# Advisory Wire

REFERENCE NO: AW700-45-0002, Rev. 17

EFFECTIVITY: Global Express  
Global 5000  
Global Express XRS

SUBJECT: **CAIMS Member System Functionality  
Status LDI Sparrow.037**

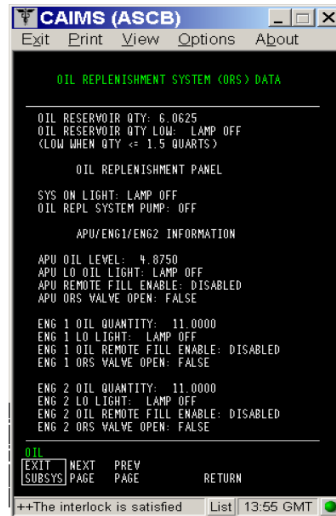
- **Changed pages “Discrete Signals – Screen 2/12 and 8/12” to clarify the Left and Right Thrust Reversers Text (ENRGZ/NOT ENRGZ and SOL ON/OFF) as follows:**

- When the discrete to DAU is ground, the relay is not energized.
  - (D38)-L TR DCV SOL NOT ENRGZ (2/12)
  - (D32)-L TR UPR DR SOL OFF
  - (D35)-L TR LWR DR SOL OFF (8/12)
  - (D38)-R TR DCV SOL NOT ENRGZ
  - (D32)-R TR UPR DR SOL OFF (8/12)
  - (D35)-R TR LWR DR SOL OFF
- Otherwise, it is ENRGZ.
  - (D38)-L TR DCV SOL ENRGZ (2/12)
  - (D32)-L TR UPR DR SOL ON
  - (D35)-L TR LWR DR SOL ON (8/12)
  - (D38)-R TR DCV SOL ENRGZ
  - (D32)-R TR UPR DR SOL ON
  - (D35)-R TR LWR DR SOL ON

- **PRIMARY FLIGHT CONTROL SURFACE POSITION:**

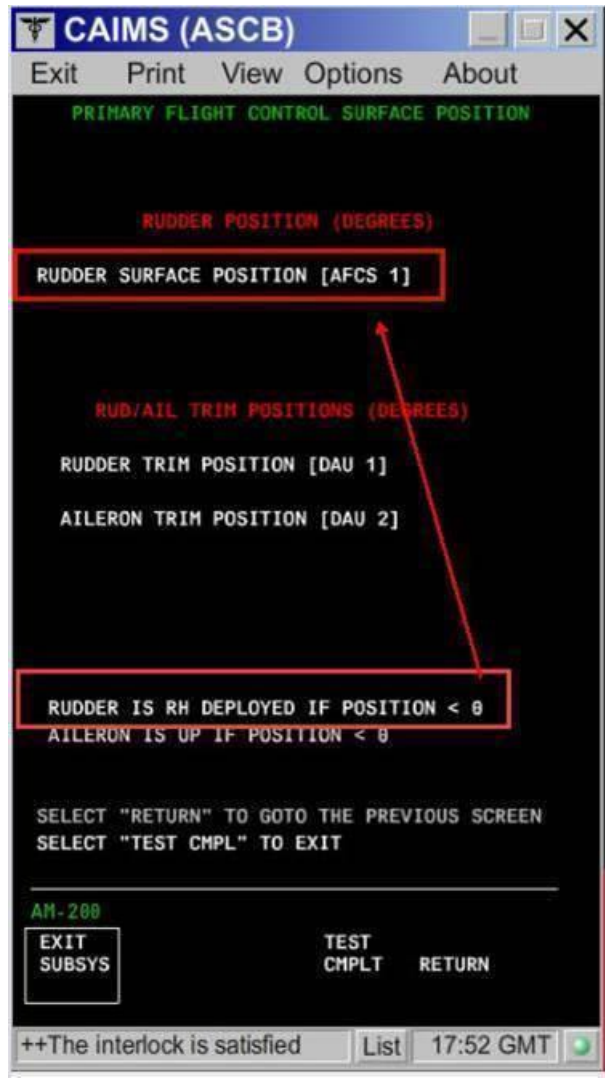
It should be noted that The Rudder position screen shot below shows reads “RUDDER IS RH DEPLOYED IF POSITION IS < 0” however, this should read “RUDDER IS RH DEPLOYED IF POSITION IS > 0”

**Note:** The same applies to "RUDDER SURFACE POSITION (AFCS 2)"

The following screen typo will be corrected at the next CAIMS LDI Database update opportunity.

### BCU Test Pages:

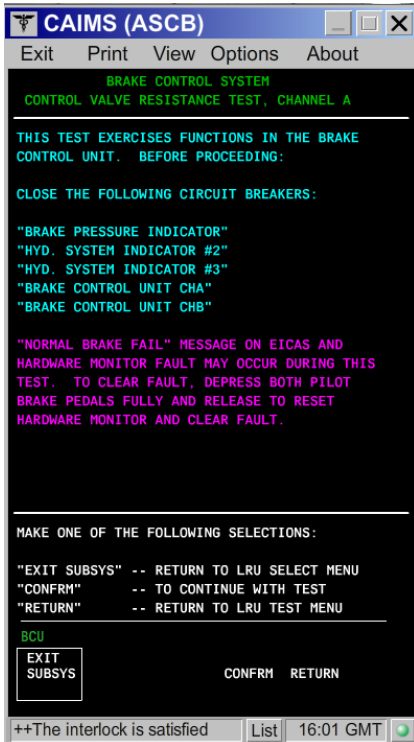
To apply MEL to a Wheel Speed Transducer (WST) coil as per DDG 32-43-05, it requires maintenance action.

This action asks for several OMS tests pages to be performed. Part of the preconditions for these tests include ensuring the following breakers are CLOSED:

- BRAKE PRESSURE INDICATOR
- HYD. SYSTEM INDICATOR #2
- HYD SYSTEM INDICATOR #3

**These circuit breakers do not exist so, it has been established that the following BCU Test Pages contain the same incorrect Circuit Breaker reference and should be updated**

1. CONTROL VALVE RESISTANCE TEST CH A
2. CONTROL VALVE RESISTANCE TEST CH B
3. DISCRETE EICAS DISPLAY TEST AUTOBRAKE
4. DISCRETE EICAS DISPLAY TEST CH A
5. DISCRETE EICAS DISPLAY TEST CH B
6. PEDAL (LVDT) LOOP BACK TEST CH A
7. PEDAL (LVDT) LOOP BACK TEST CH B
8. PRESSURE PULSE TEST CH A AND CH B
9. SHUTOFF VALVE OPERATION TEST CH A AND CH B
10. WHEEL SPEED XDCR RESISTANCE TEST CH A
11. WHEEL SPEED XDCR RESISTANCE TEST CH B
12. HARDWARE MONITOR OPERATION CH A
13. HARDWARE MONITOR OPERATION CH B

Future LDI change will be required to be applied to the thirteen (13) Test Pages to modify the circuit breakers reference instructions of the first page

**“WAS”: CLOSE THE FOLLOWING CIRCUIT BREAKERS:**

- "BRAKE PRESSURE INDICATOR"
- "HYD. SYSTEM INDICATOR #2"
- "HYD. SYSTEM INDICATOR #3"
- "BRAKE CONTROL UNIT CH A"
- "BRAKE CONTROL UNIT CH B"

**“IS”: CLOSE THE FOLLOWING CIRCUIT BREAKERS:**

- EMS CDU IND/RECORD “DCU 1A PRI” and “DCU 1B PRI”
- EMS CDU IND/RECORD “DCU 1A SEC” and “DCU 1B SEC”
- EMS CDU IND/RECORD “DCU 2A PRI” and “DCU 2B PRI”
- EMS CDU IND/RECORD “DCU 2A SEC” and “DCU 2B SEC”
- EMS CDU LDG GEAR “BRAKE CTL CH A” and “BRAKE CTL CH B”
- EMS CDU HYD “HYD 2 PRESS XDCR” and “HYD 3 PRESS XDCR”
